[Docket No. FAA-2023-1650; Project Identifier AD-2023-00795-T; Amendment 39-22517; AD 2023-15-05]

Airworthiness Directives; The Boeing Company Airplanes

ACTION: Final rule; request for comments.

Figure 1 to paragraph (g) - Engine anti-ice AFM revision

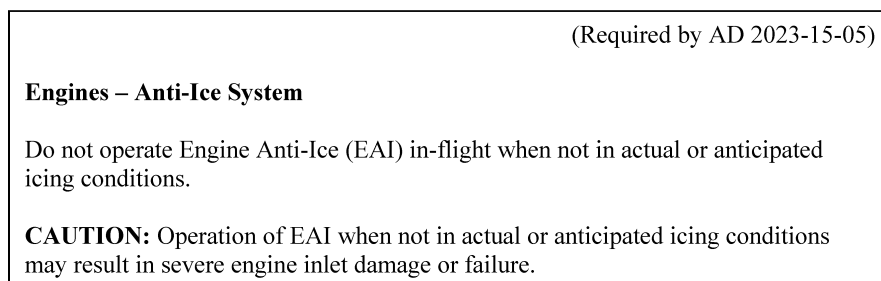
Within 15 days after the effective date of this AD: Revise the Limitations Section of the existing AFM to include the information specified in figure 1 to paragraph (g) of this AD. This may be done by inserting a copy of figure 1 to paragraph (g) of this AD into the existing AFM.
